DRAINAGE LETTER REPORT

**SHOPS AT MERIDIAN RANCH CONVENIENCE STORE
11810 STAPLETON DRIVE
LOT 2, THE SHOPS FILING NO. 1A AT MERIDIAN RANCH**

May 5, 2023
Revised September 18, 2023
Revised January 8, 2024

**JPS Project No. 092202
PCD Filing No. PPR2322 and VR2314**

| SHEET: | RR-1 |

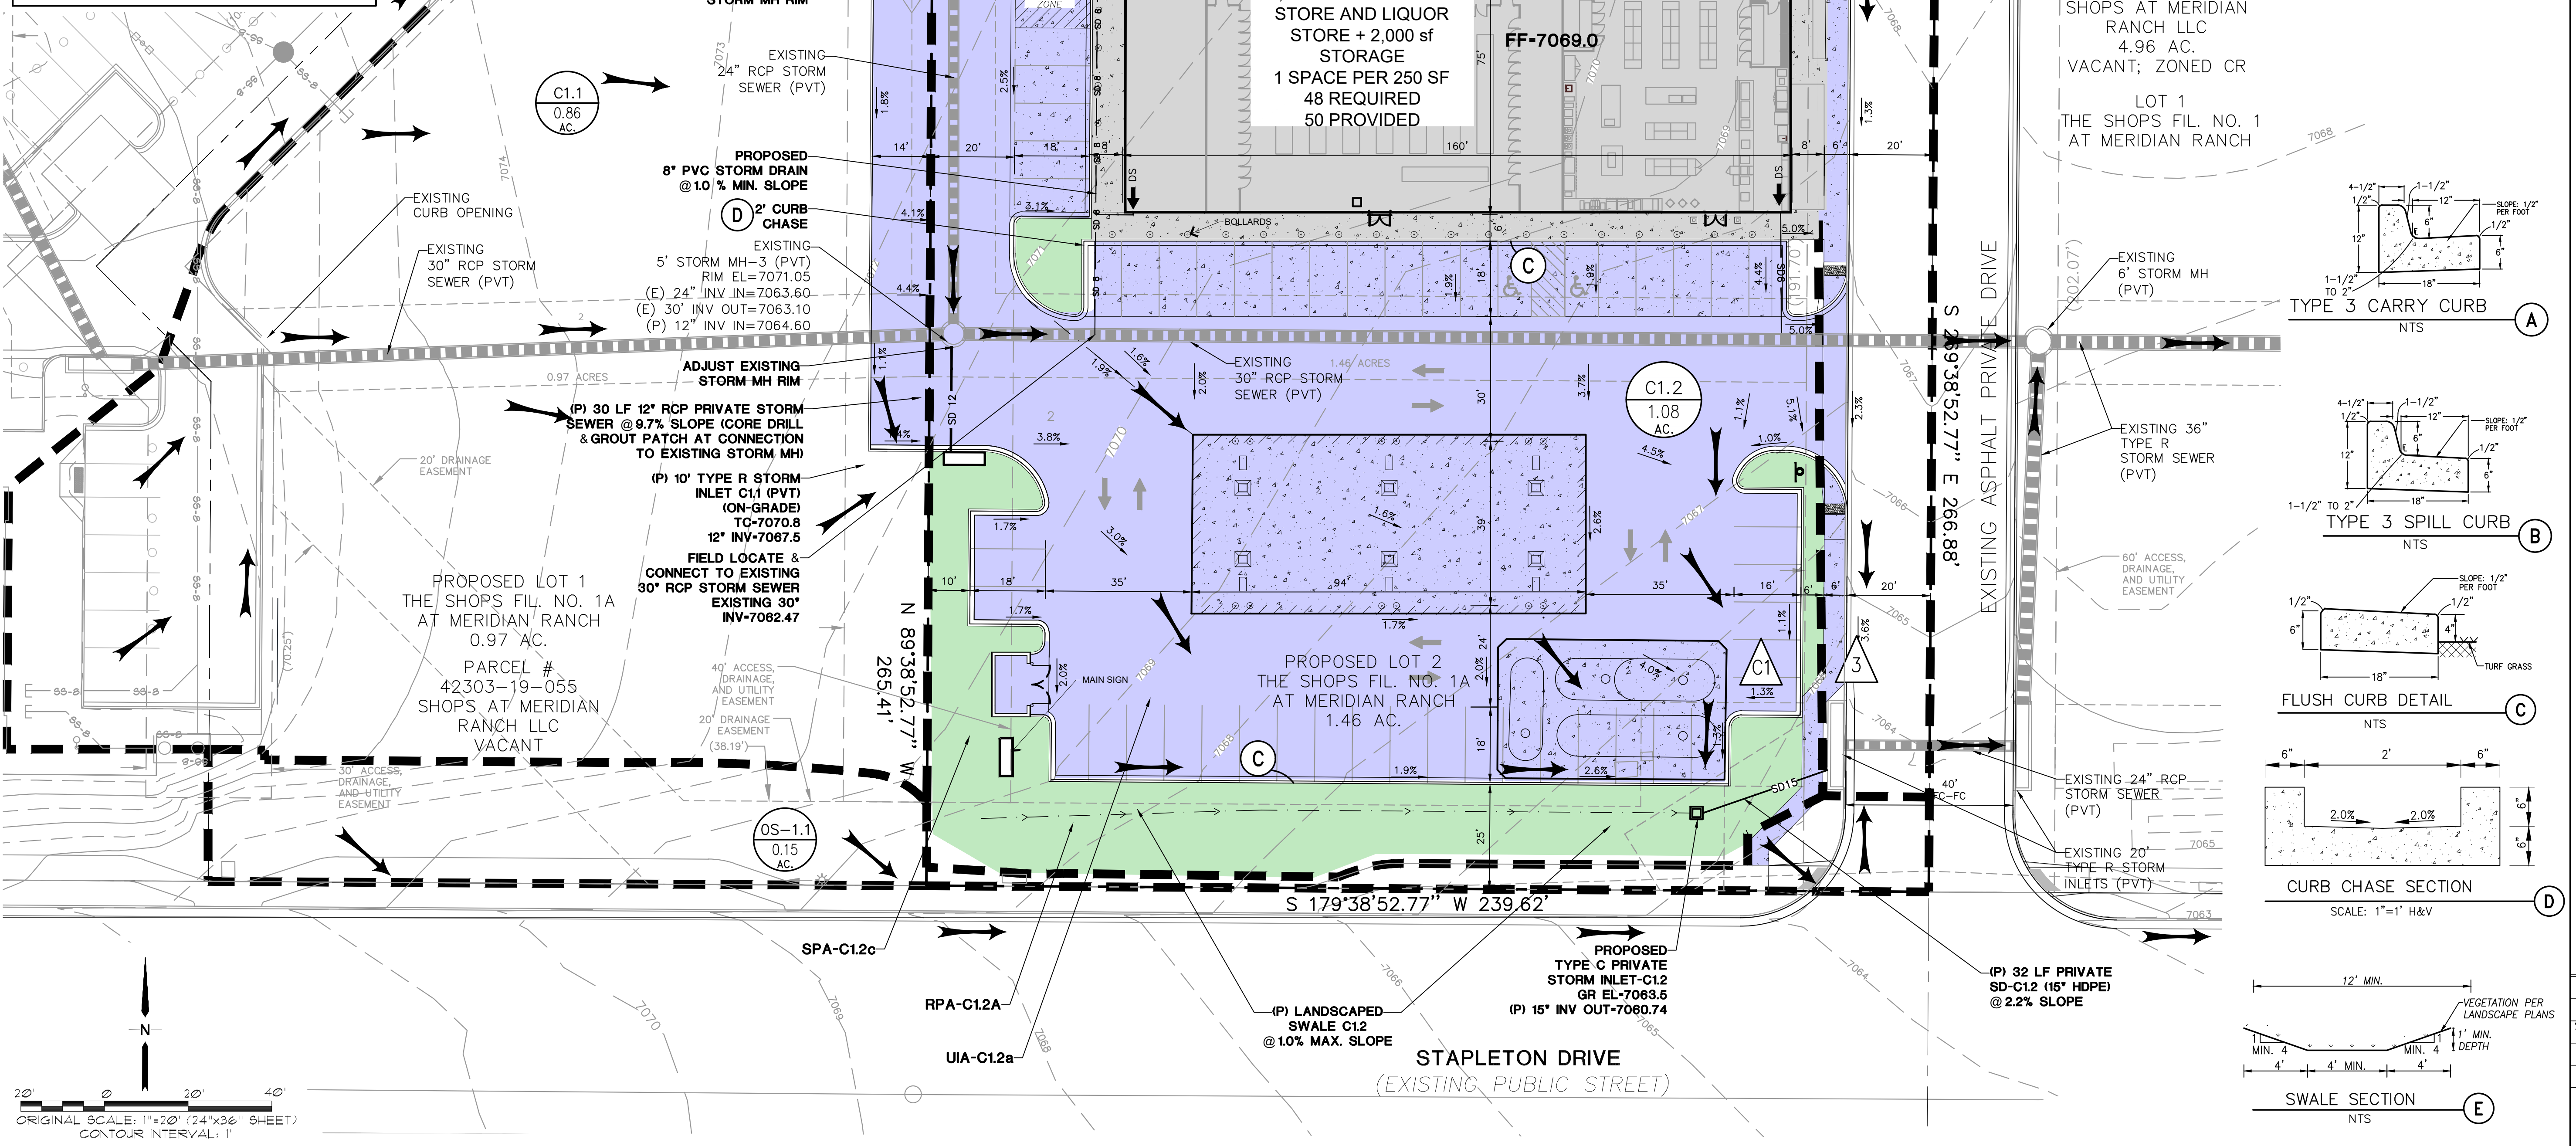
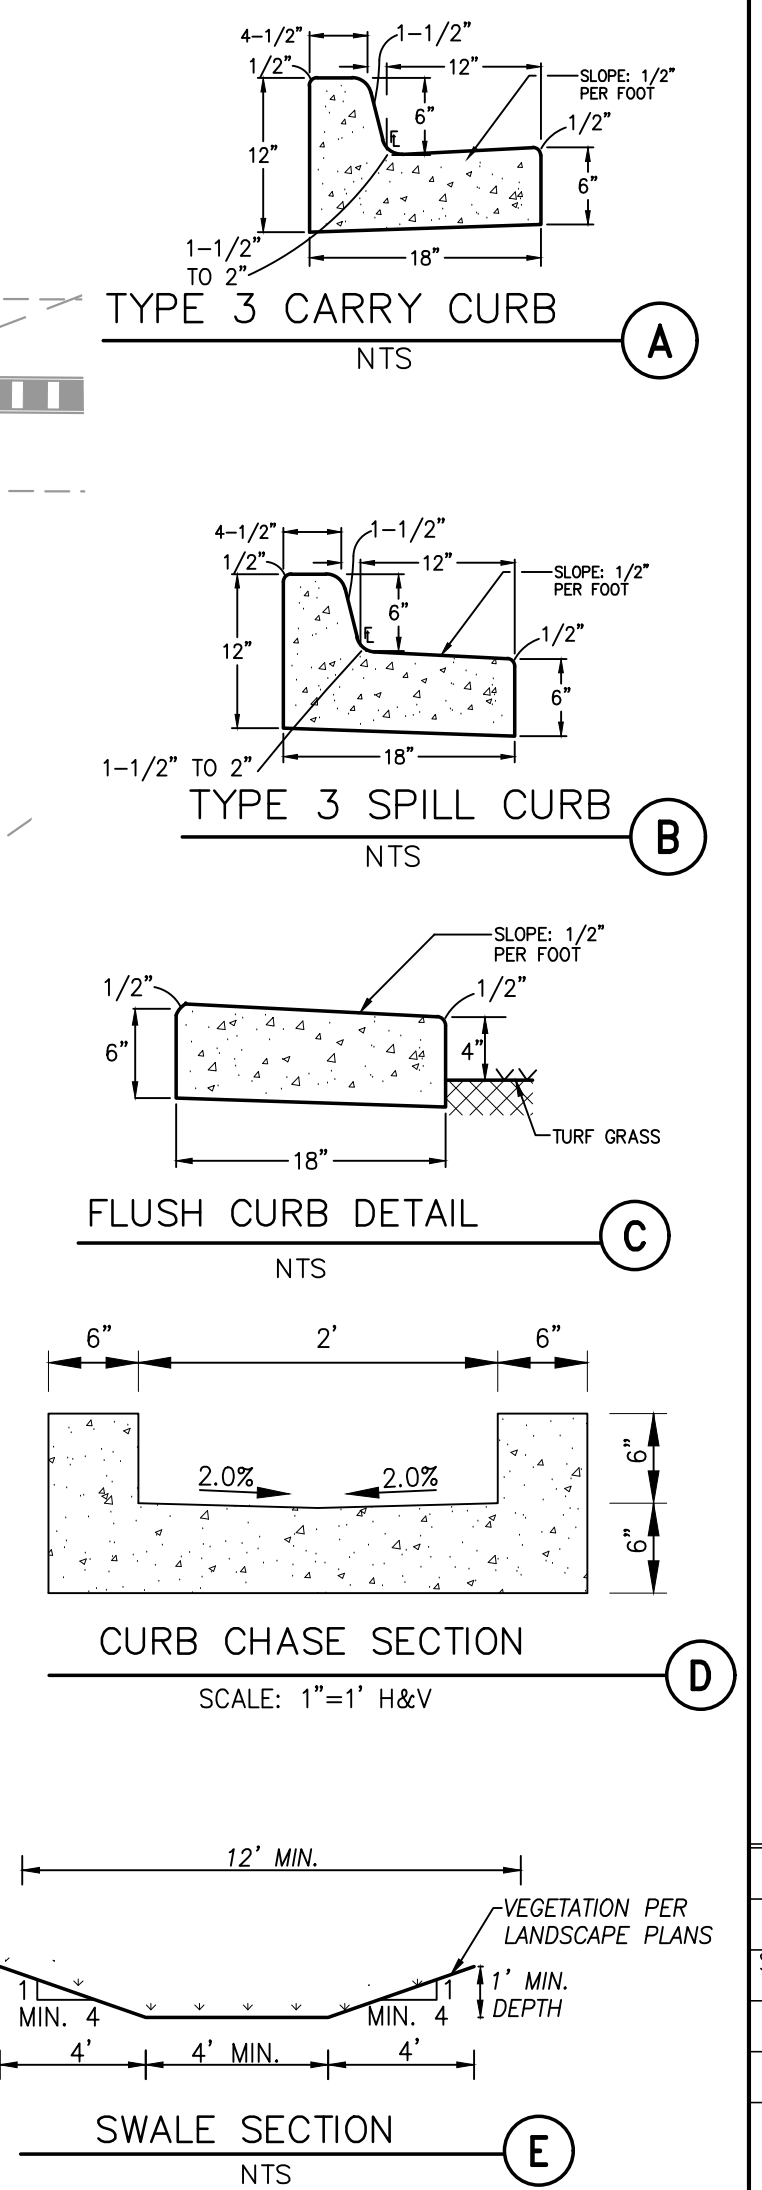
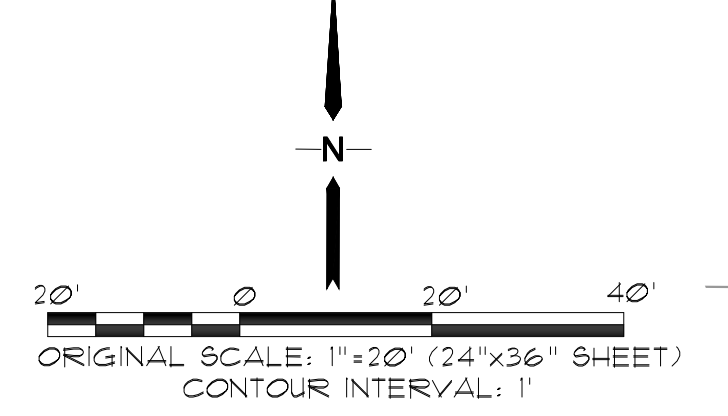
Comment generated due to changes in the document from previous submittal:
The report text above states that WQ treatment will be provided by the existing downstream Bennett Ranch Pond. This map would be required if you were utilizing runoff reduction to achieve water quality treatment. But you're not, so it's a little confusing and contradictory to have it included in this report. It would however be helpful to re-purpose this map to show that you are complying with the 20/10 rule discussed in the report text (PDF pg 8) by showing the 3700sq ft of swale area that meets the req's of that rule. And rename this exhibit's title and update the legend accordingly.
